# CITY OF ALBUQUERQUE

**Re:** Sigma Chi Parking Lot  
**1835 Lomas Blvd NE**  
**Traffic Circulation Layout**  
Engineer's Stamp dated 12-06-16 (J15D098)

Re: Sigma Chi Parking Lot  
1835 Lomas Blvd NE  
Traffic Circulation Layout  
Engineer's Stamp 08-02-16 (J15D098)

**RE: Sigma Chi Parking Lot  
Grading and Drainage Plan  
Engineer's Stamp Date – 8-2-2016  
Hydrology File: J15D098**

NORTH 70' OF LOT 7, 8, 9, BLOCK 4 SIGMA CHI ADDITION	DRAWN BY JDC
	GRADING AND DRAINAGE PLAN	DATE 07-18-2016
		SHEET #
		1 OF 1
DAVID SOULE P.E. #14522		JOB #

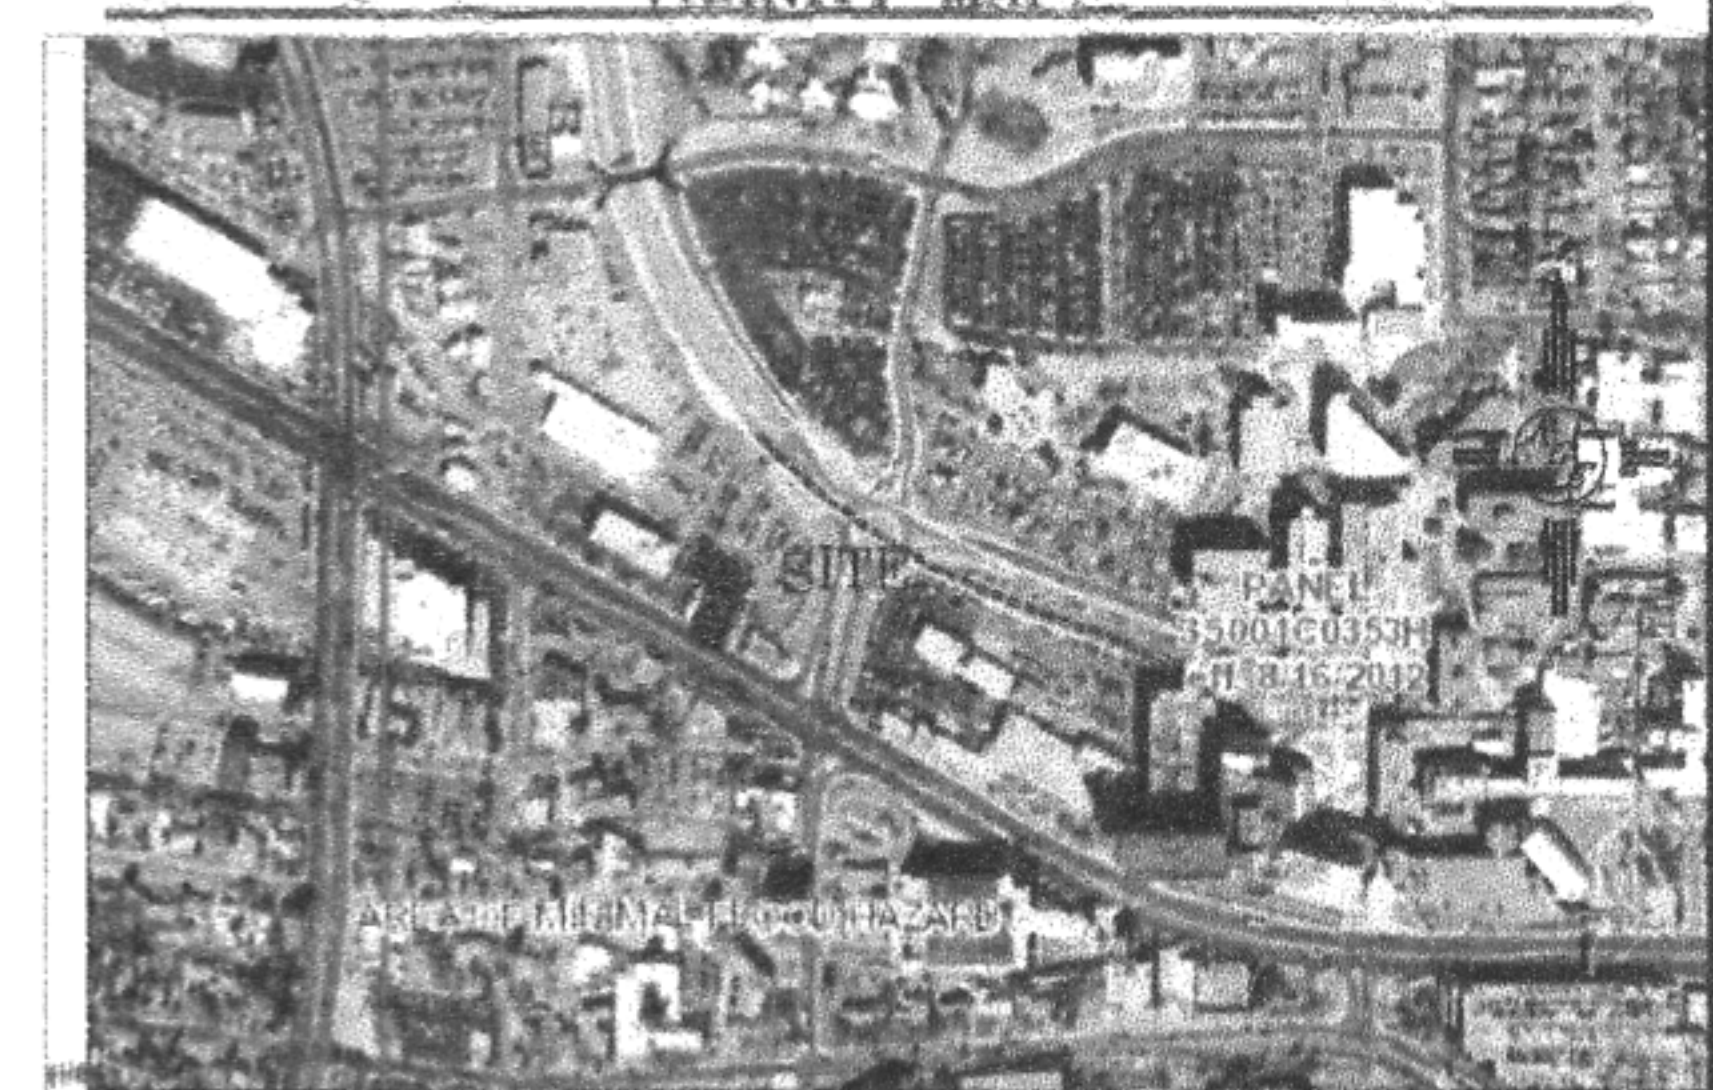
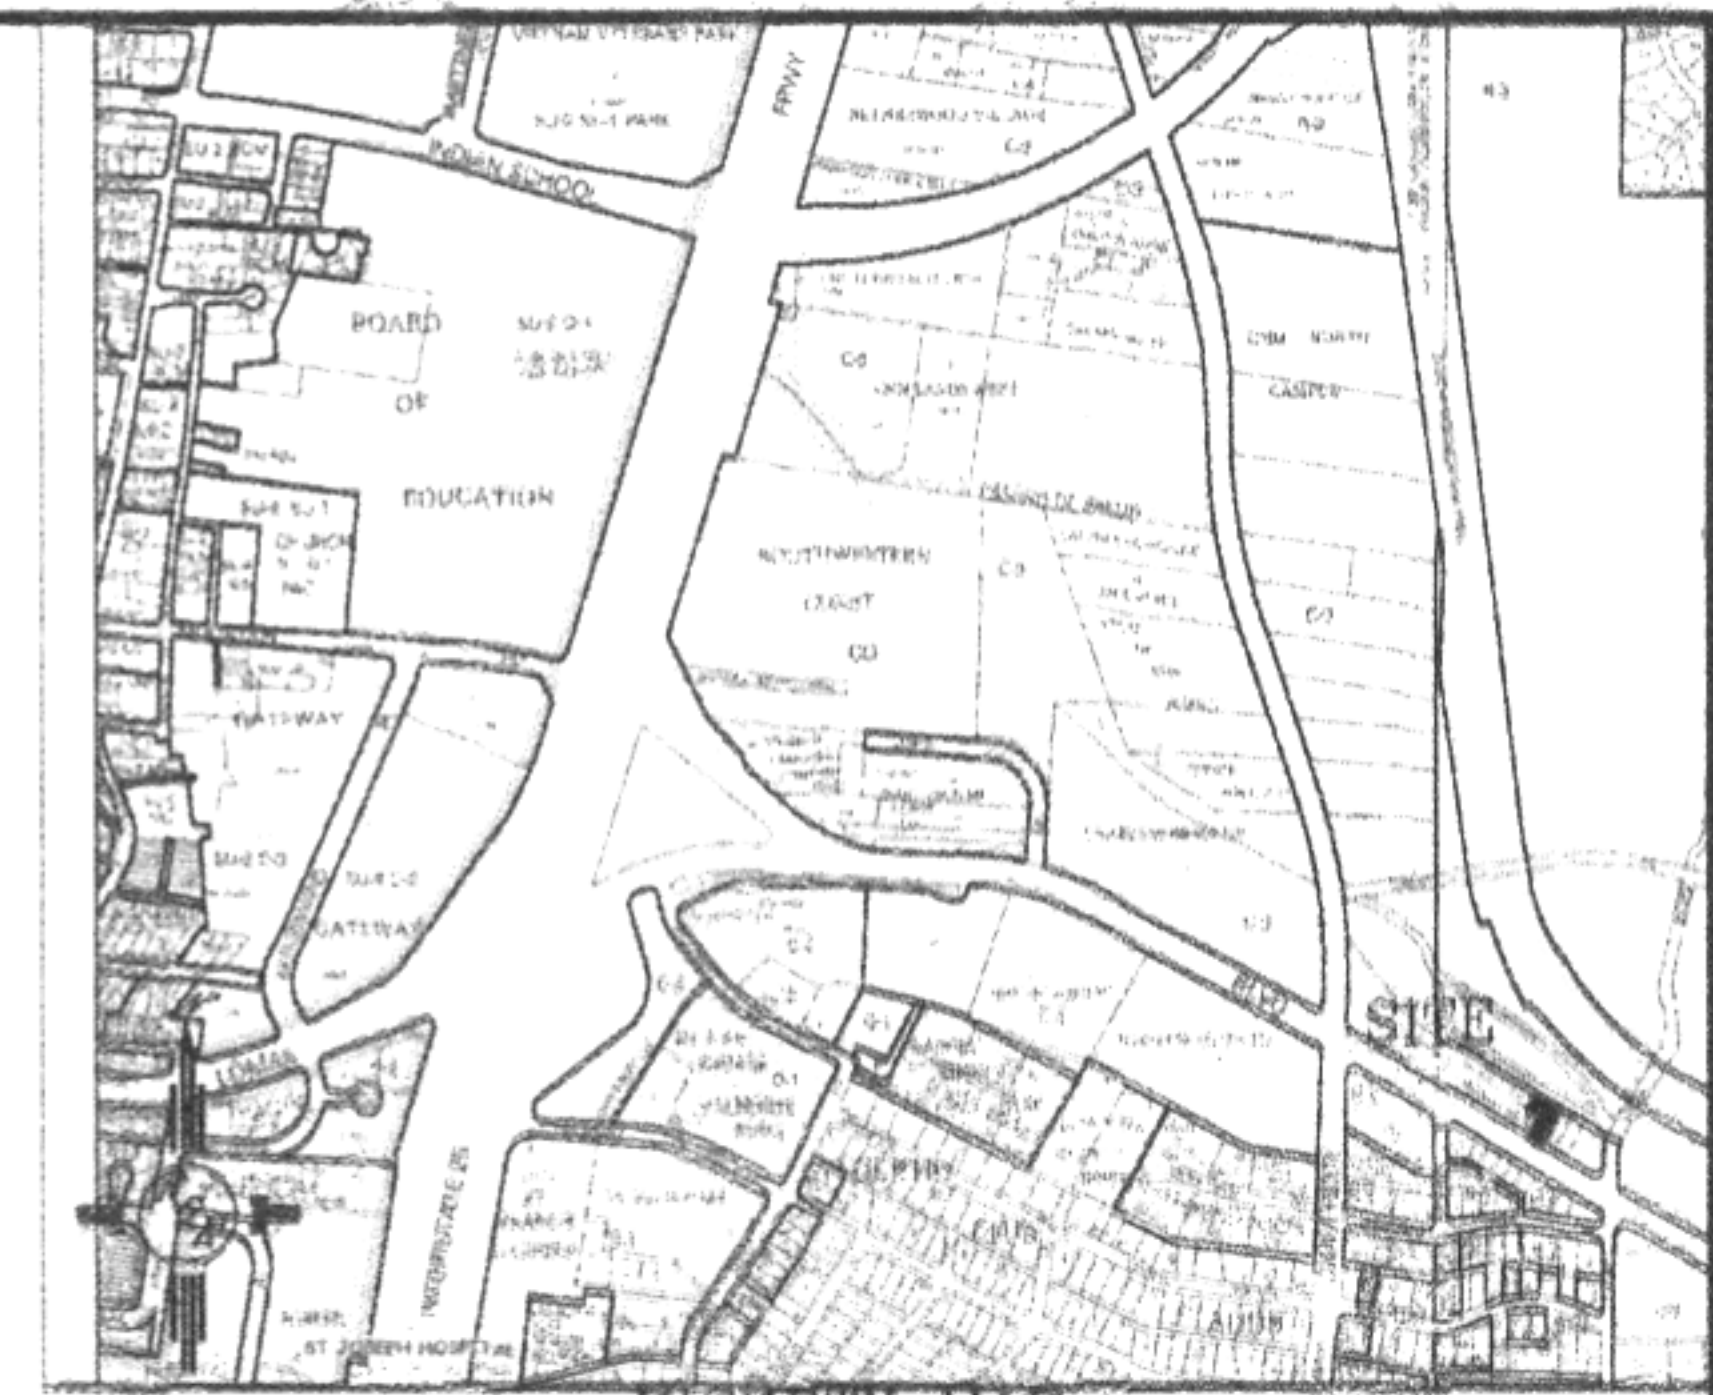
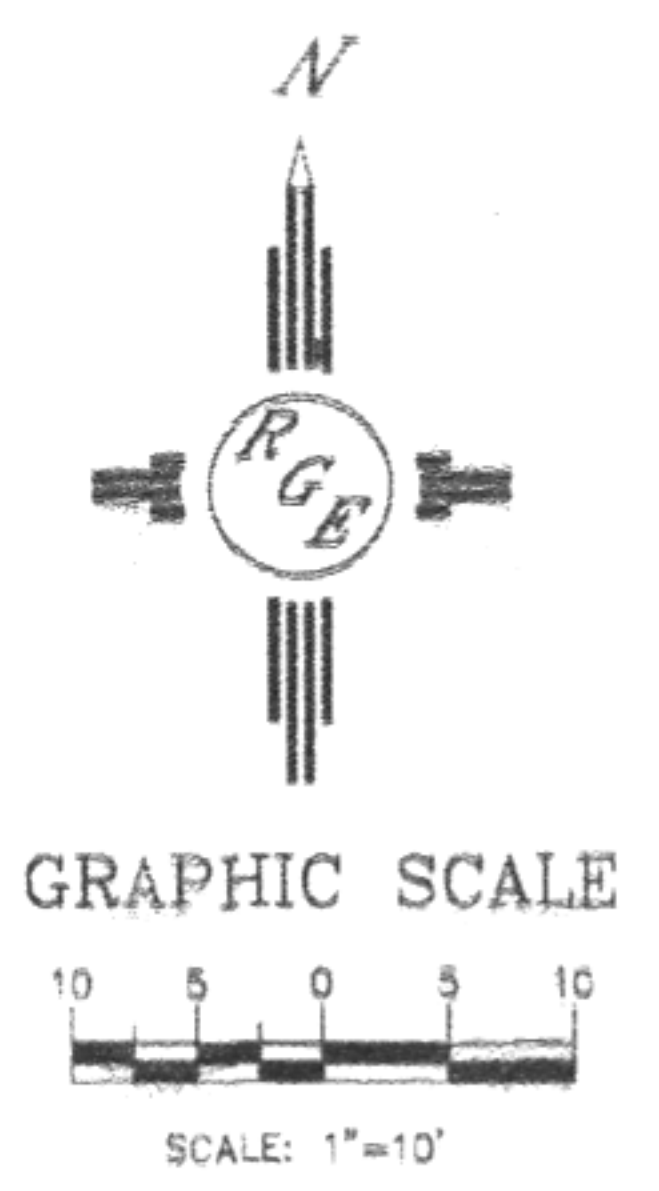
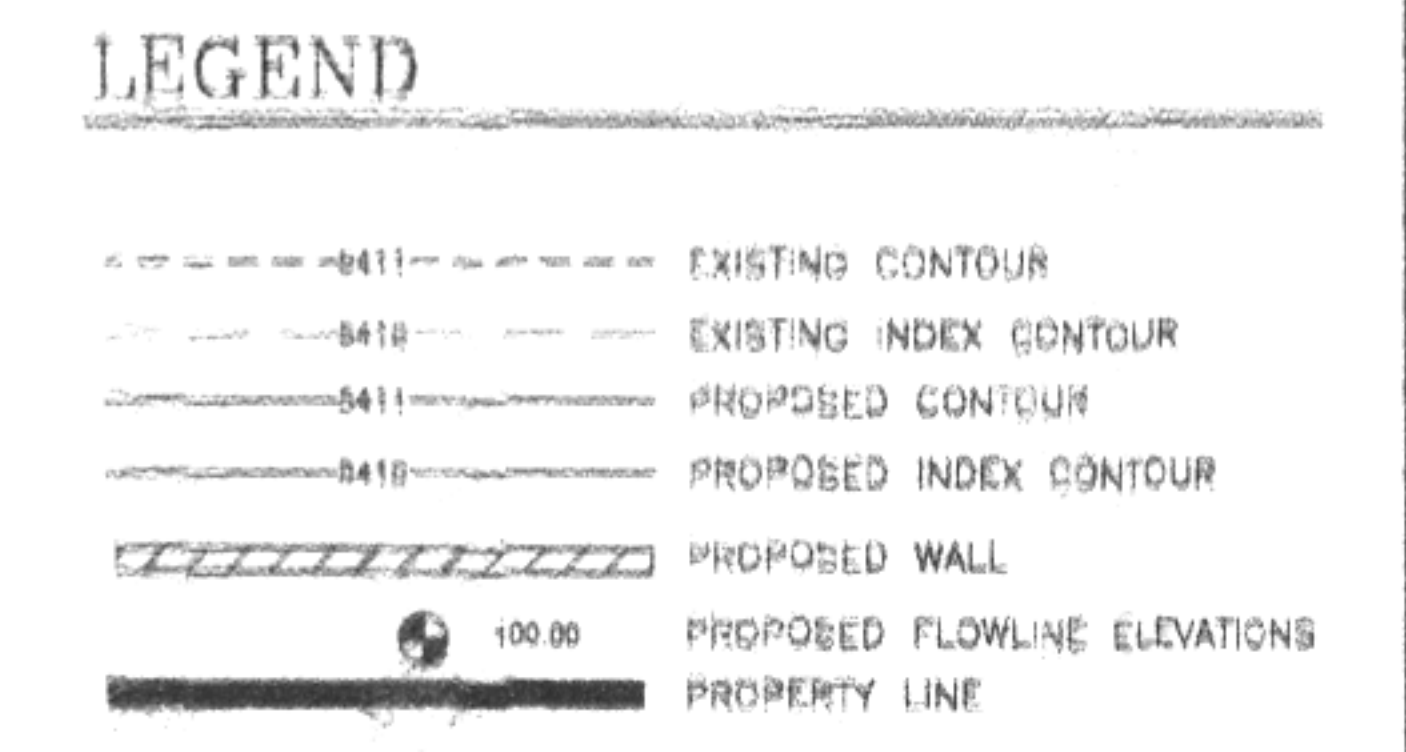
1. Remove the 4" pvc drain that is proposed through the sidewalk, which would require an SO-19 Permit. Instead, a curb cut outlet facing the driveway can provide a spillway for the adjacent pond.
2. Ensure that curb cuts are constructed on all the islands at logical low spots; some are not shown on the plan.
